PRESTON COUNTY BOARD OF EDUCATION  
KINGWOOD, WEST VIRGINIA  
**PRESTON HIGH SCHOOL**  
**HVAC UPGRADES**

**ADDENDUM #2**

**March 26, 2021**  
**THRASHER PROJECT #101-060-10138**

**SK-M1**

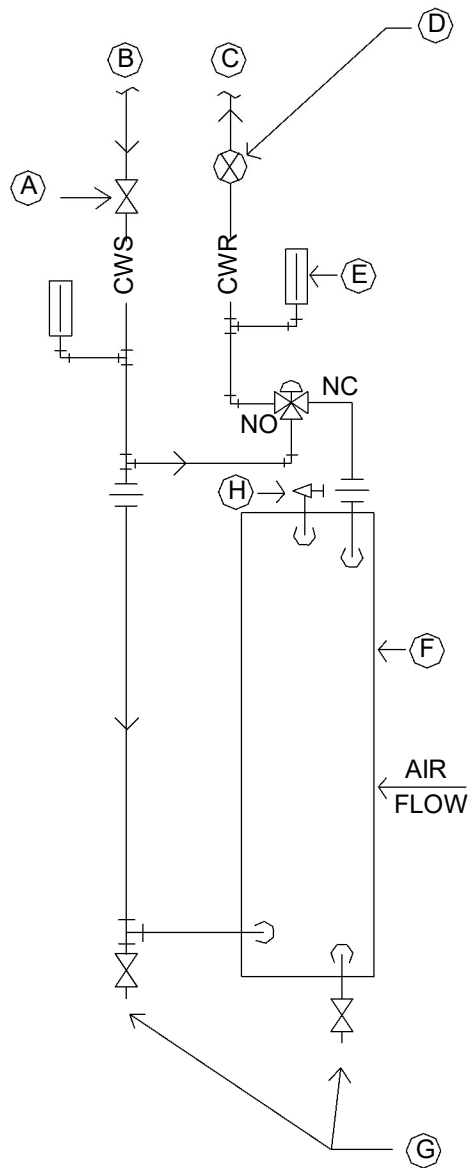
**QUESTION #4:** Can a coil connection detail be provided showing all required components?

**RESPONSE:** See attached sketch SK-M1.
